ADMIRAL 4C4 Preamplifier and 8D3 Power Unit

4C4 RUN 11 PREAMPLIFIER SCHEMATIC

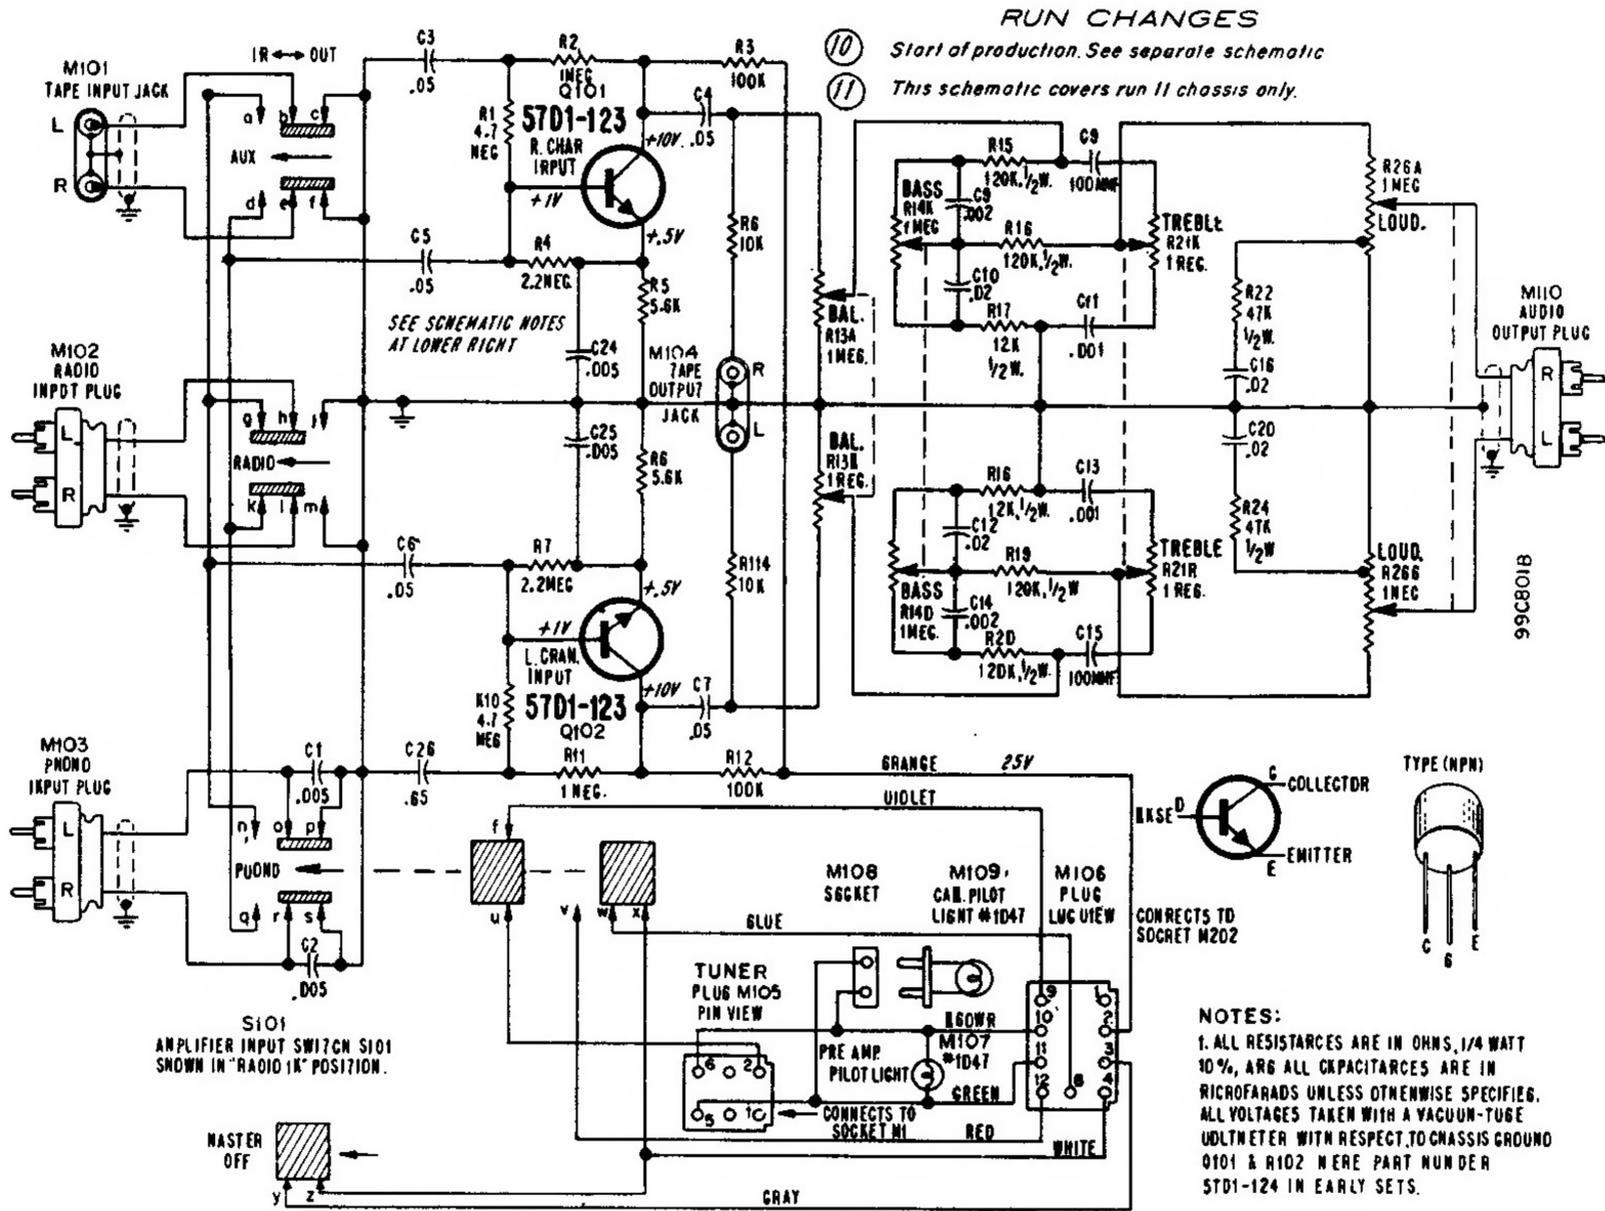
- (10) Start of production
- (11) To improve bass response, C203 & C208 changed from .03mf to .05mf.
